SERVICE BULLETIN

APPLICABILITY: 2019MY Forester
SUBJECT: Rattling Sound from Front Door

NUMBER: 12-263-19
DATE: 05/13/19

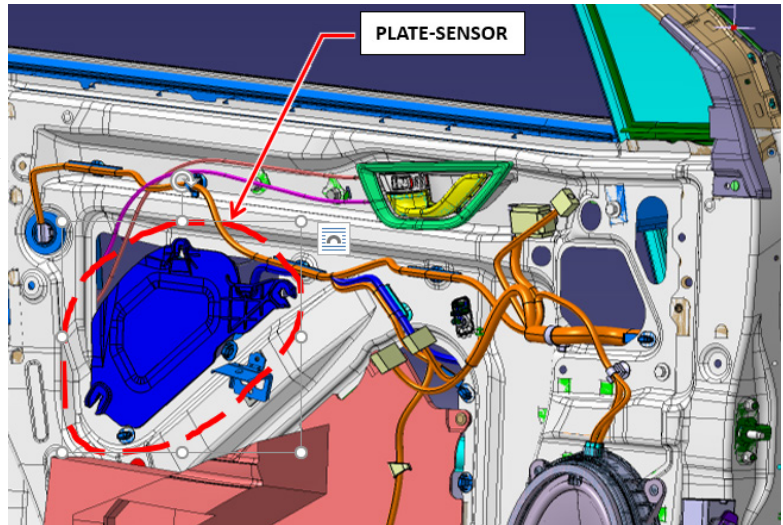
Step 3: CAREFULLY remove the vapor barrier from the inner door structure *only as much as necessary* to access and remove the PLATE-SENSOR as shown here in the illustration.

Step 4: CAREFULLY remove the PLATE-SENSOR from the inner door structure using a trim clip removal tool. **NOTE:** Any damaged retaining clips MUST be replaced before reinstallation.

Foam Sealer Application Area

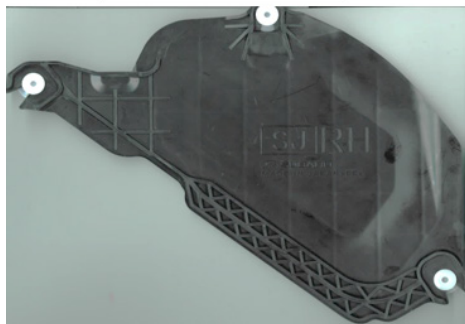
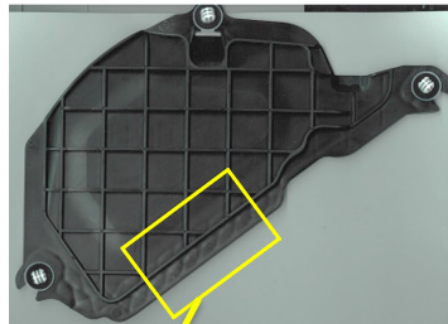
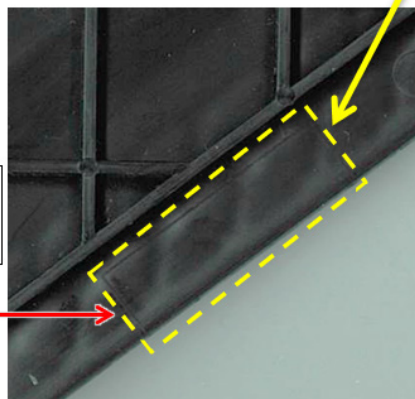
Step 6: Using the photos provided below as a guide for positioning, clean the area on the back face (ribbed side) of the PLATE-SENSOR where the sealer is to be applied with a mild solvent on a clean shop. Dry the area thoroughly.

Step 7: Peel and apply the EPT foam sealer to the PLATE-SENSOR as shown above.

Step 5: Cut a piece of the EPT foam sealer 1-3/16" long (30mm).
